MONTGOMERY COUNTY HISTORIC PRESERVATION COMMISSION
STAFF REPORT

Address:	66 Walnut Ave., Takoma Park	Meeting Date:	2/22/2023
Resource:	Contributing Resource Takoma Park Historic District	Report Date:	2/15/2023
Applicant:	Peter Hendrickson Eric Teran, Architect	Public Notice:	2/8/2023
Review:	HAWP	Tax Credit:	n/a
Permit No.:	997894 REVISION	Staff:	Dan Bruechert
Proposal:	Revision to previously approved HAWP for alterations to deck construction.

PROPOSAL

Figure 2: The approved 1st-floor plan from the 8/17/2022 HAWP.

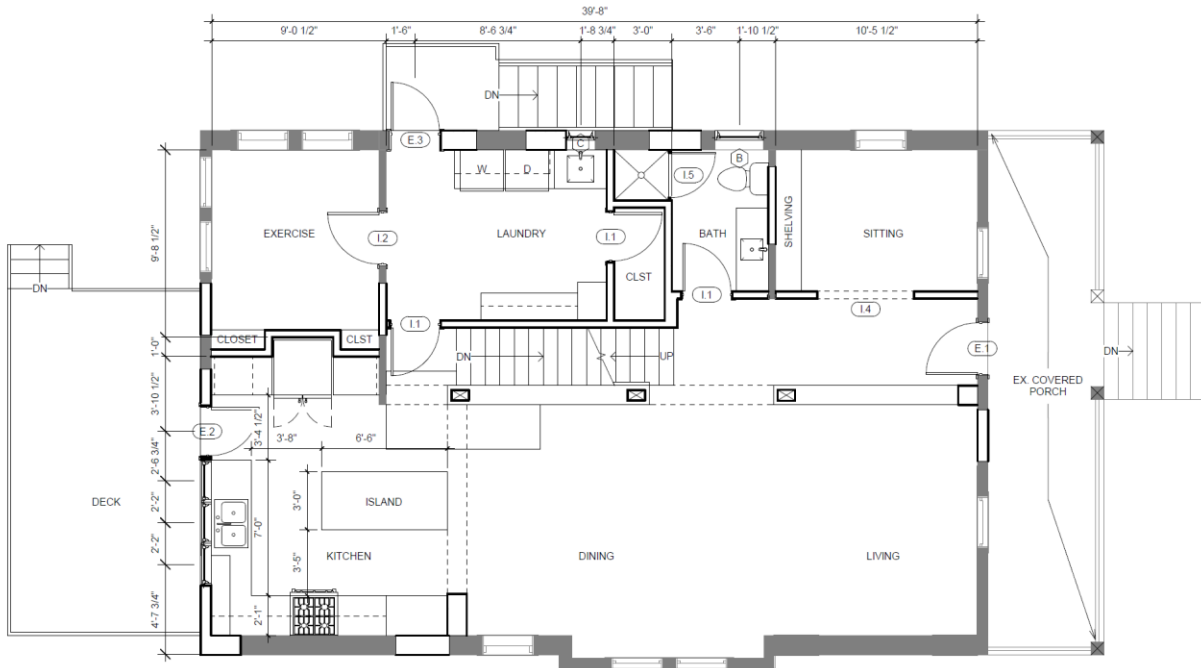
The subject property is a front gable Craftsman bungalow with non-historic large, shed dormers, and additional entrances that likely date from the time the house was divided into a multi-unit residence. The house was covered in vinyl siding in the 1990s.² As an amendment to the previous HAWP, the applicant proposes to extend the rear deck to wrap around the rear corner.

Figure 3: Revised proposal to extend the deck and wrap around the rear corner.

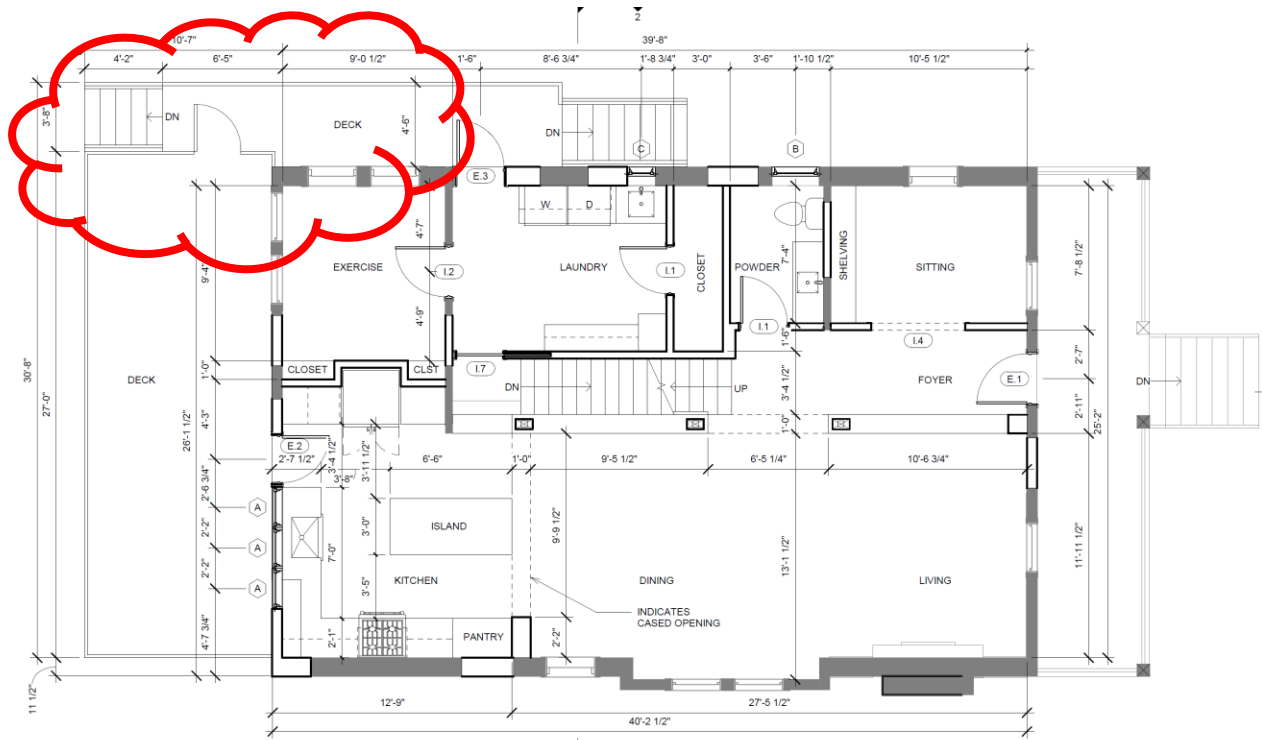
The deck extension will match the height, materials (wood), and design of the approved deck. The expanded deck will be visible from a narrow view along the right side of the house; however, Staff does not find that the expanded deck will negatively impact the pattern of open spaces found in this section of the Takoma Park Historic District nor will it detract from the house’s architectural character. Staff recommends the HPC approve the amended HAWP under 24A-8(b)(2) and (d) and Standards 2, 9, and 10 and the *Design Guidelines*.

Staff recommends that the Commission **approve** the HAWP application under the Criteria for Issuance in Chapter 24A-8(b)(1), (2), and (d), having found that the proposal will not substantially alter the exterior features of the historic resource and is compatible in character with the district and the purposes of Chapter 24A;
